REQUEST FOR INFORMATION **DATE:** April 03, 2017 **NO.:** RFI-506

Project Name: 15051-Webster University Interdisciplinary Science Building

Subject: "header detail" at corridor C130 to SIM lab

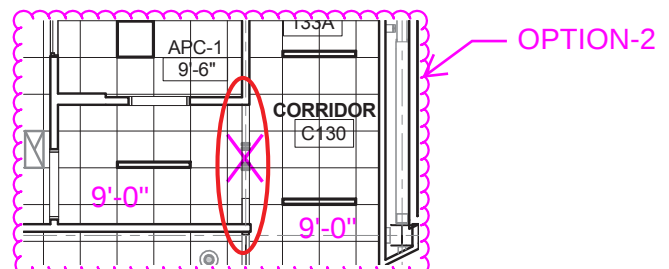
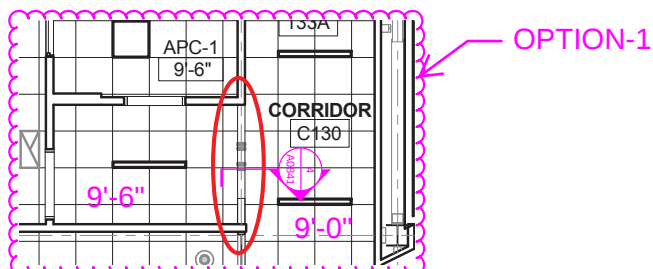
A0701.B shows what appears to be a header from corridor C130 heading into the SIM lab, however the floor plans do not show anything at this location at A0201. Please confirm if there is something that needs to be built here or if the ceiling continues through without a break.

IF THERE IS NO COST CHANGE INVOLVED, OPTION-1 IS PREFERRED.
IF THERE IS COST CHANGE, PROCEED WITH OPTION-2.

OPTION-1: CEILING STEPS UP TO 9'-6" FROM CORRIDOR C130 (WHICH AT 9'-0").
TRANSITION DETAIL PER 4/A0841

OPTION-2: NO HEADER. CEILING OF CORRIDOR C130 CONTINUES THROUGH
WITHOUT BREAK AT 9'-0".
